THE WARNER AIRCRAFT CORPORATION

SERVICE LETTER NO. A-13

- Subject:
- I. Pistons-Procedure of Inspection and Replacement.
  - II. Exhaust Valve-Procedure of Inspection and Replacement.
  - III. Cylinder Attaching Stud-Proper Inspection and Assembly Procedure.
  - IV. Link Rod-Proper Fit of Wrist Pin.

FIGURE 1

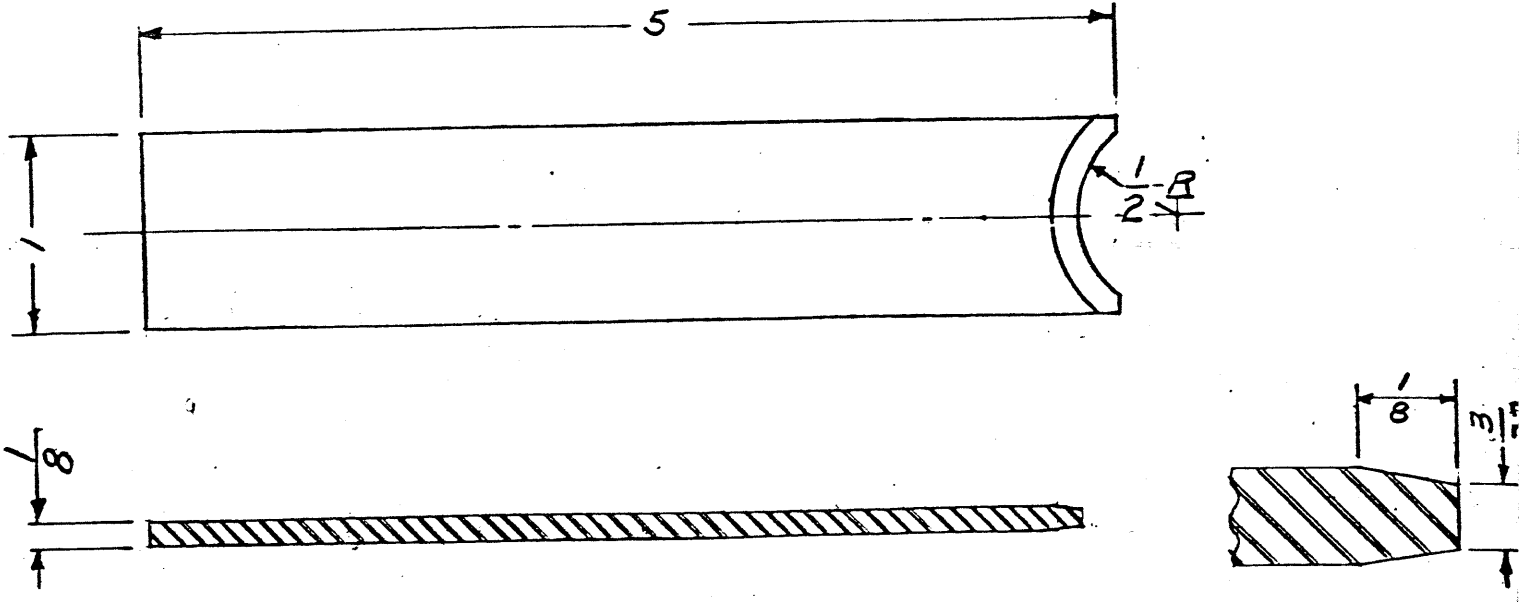
- (2) The wrist pin must be a hard push or light drive fit in the link rod. Wrist pins which are found loose in the rod can be salvaged by having the pin hard chrome plated on the exterior surfaces the necessary amount to obtain from .0002 to .001 press fit of the wrist pin in the link rod. After the pin has been plated it must be carefully polished with crocus cloth and any build-up of the plating on sharp edges must be removed. The wrist pin must then be tried in the bushings of the master rod, where it must be from .0007 to .0015 loose which can be determined by slipping a feeler of the above thickness with the wrist pin into the bushing. If the bushing is found too small, it must be carefully reamed out with an expansion reamer. It will be found that on the master rod the link rod bushings are not flush with the inner surfaces of the master rod, since they are pressed in to a distance of .875 + .001 to .0000 between the bushing, as indicated in Figure 2 on Page 9, in order to locate the link rod for side clearance. In order to prevent dislocation of these bushings when the wrist pin is pushed in or out of the link rod, a wedge shape tool, as shown in Figure 1, must be made and this tool is to be inserted between the link rod and the master rod as shown in Figure 2, so that the force transmitter to the wrist pin is transmitted from the link rod directly to the master rod without dislocating the wrist pin bushing in the master rod. Due to the fact that the wrist pin bushing may protrude from the outer surface of the rod, it is important that the support for the master rod be made so that it clears the outer end of the lower wrist pin bushing as shown in Figure 2.
